Subject: **DEP File No. 0870004-004-AC; PSD-FL-285  
Unit 9, Marathon Generation Plant**

Subject: **DEP File No. 0870004-004-AC; PSD-FL-285  
Unit 9, Marathon Generation Plant**

SUBJ: PSD Permit Application for Florida Keys Electric Cooperative - Marathon Generation Plant (PSD-FL-285) located in Monroe County, Florida

Subject: **Response to Letter Dated May 16, 2000** *0870004-004-A*  
**Unit 9 Air Construction Permit Application, Marathon** *PSD-FL-285*  
**Generation Plant**

**Figure A**  
**NOx Impacts**  
**Greater Than**  
**50 ug/m3**

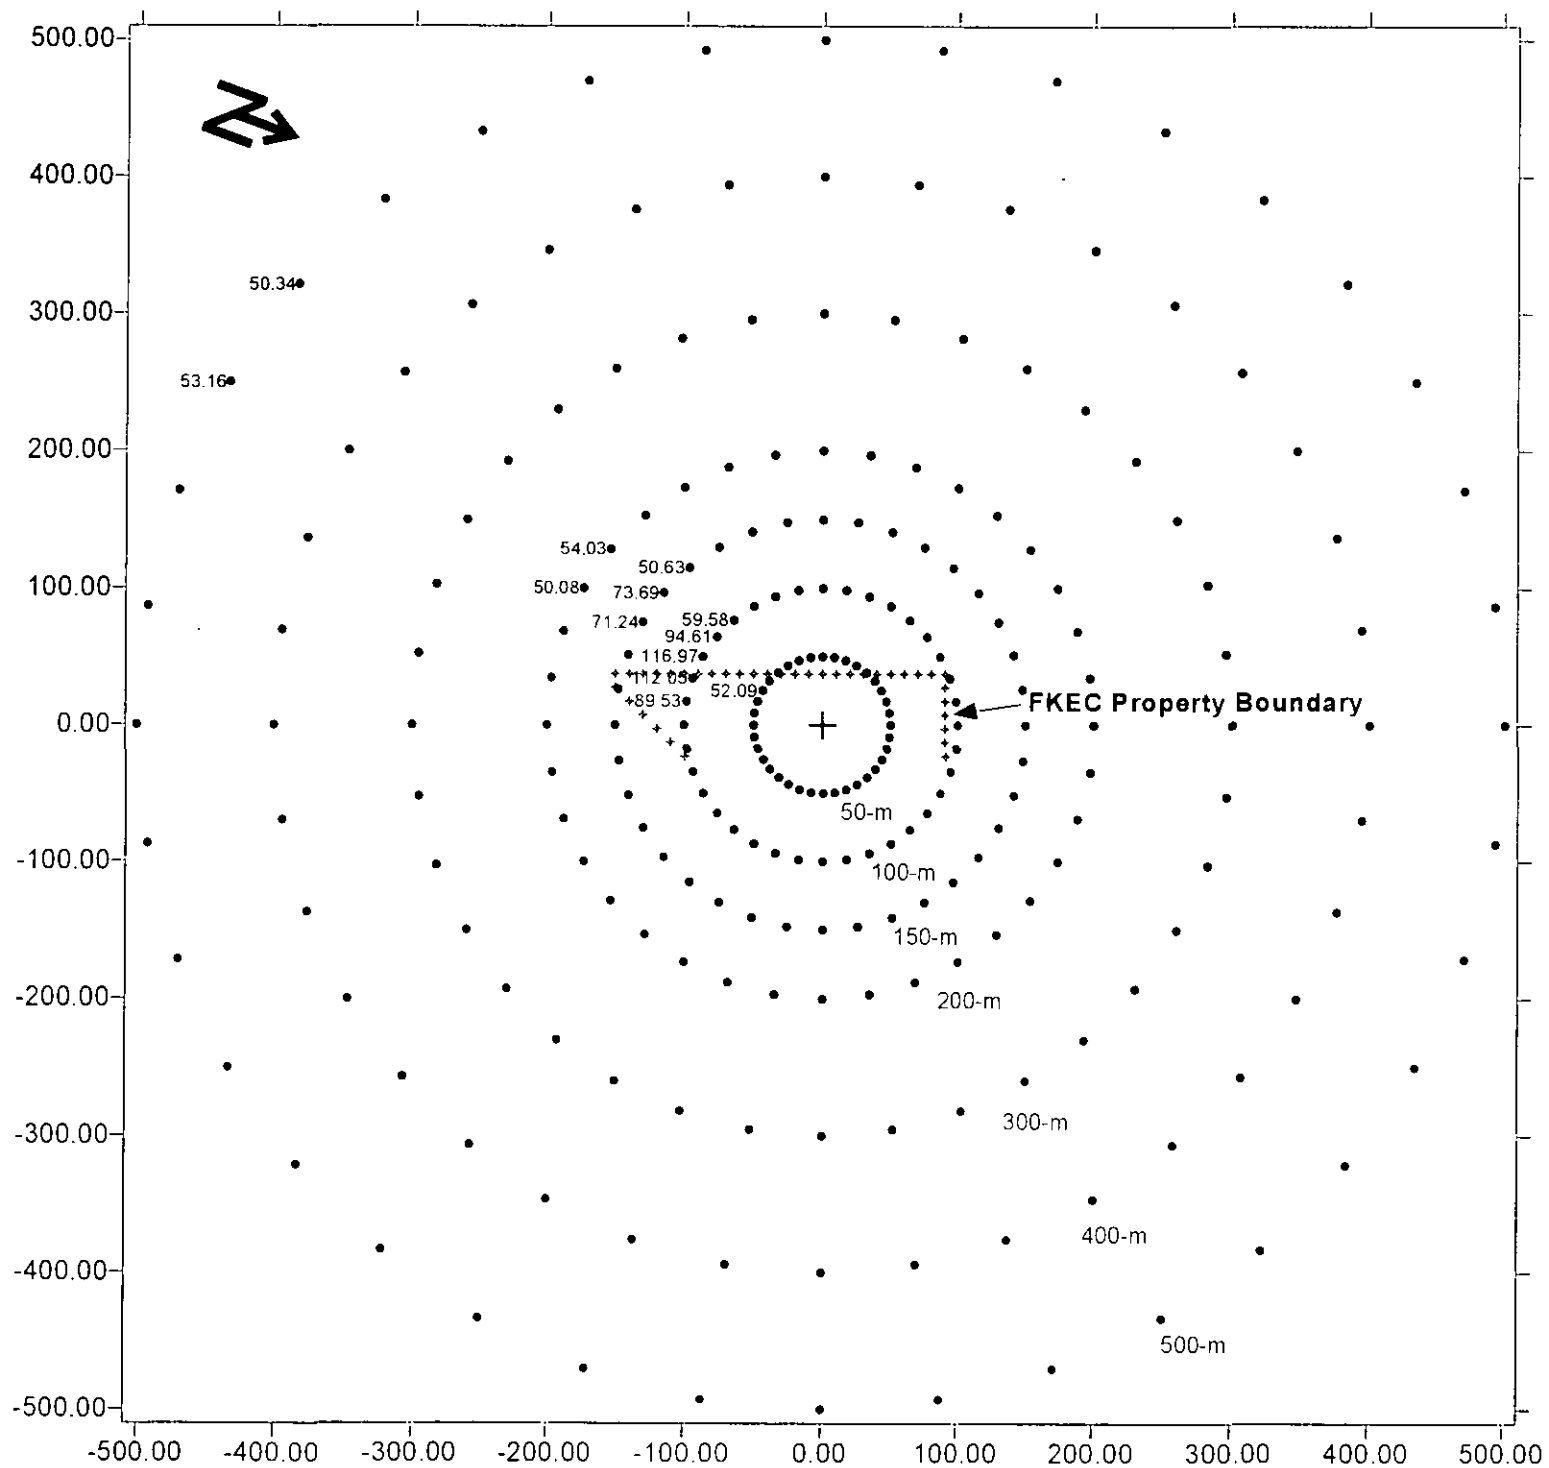
**COMMENT:** What are the modeled significant impact areas for  $PM_{10}$  and  $NO_x$ ? Were all contemporaneous increases and decreases in  $PM_{10}$  emissions at Units 1-7 accounted for in the significant impact modeling?

**RESPONSE:** The significant impact areas (SIAs) for  $PM_{10}$  and  $NO_x$ , when modeling only Unit 9, are 150 meters and 5000 meters, respectively. However, due to the absence of large sources nearby (interactive sources), maximum predicted impacts, when modeling all sources at the Marathon Generation Plant, are located well within the SIAs. The modeling runs that are included with this submittal have been revised to include receptors that extend out to the predicted SIAs. Final maximum predicted impacts and their locations have not changed from those that were previously submitted.

Figure A, which is attached to this submittal, depicts the receptor grid network out to 500 meters and the location of all  $NO_x$  impacts greater than  $50 \text{ ug/m}^3$  or half of the  $NO_x$  annual standard ( $100 \text{ ug/m}^3$ ). The impact at each receptor was determined by taking the maximum concentration at each receptor when modeling all five years of meteorological data. All impacts at receptors greater than 500 meters from the site were equal to or less than  $50 \text{ ug/m}^3$ . As shown in Figure A, three maximum impacts are occurring on FKEC's property. Additionally, there is only one impact, slightly off the property boundary, that is greater than  $100 \text{ ug/m}^3$ . As explained in the *Application*, this impact can be reduced by 25 percent due to the ratio of  $NO_2$  to  $NO_x$  in accordance with USEPA-approved practices and consistent with the modeling protocol. All  $PM_{10}$  annual and 24-hour impacts fall below 50 percent of each averaging interval's respective standard,  $50 \text{ ug/m}^3$  and  $150 \text{ ug/m}^3$ .
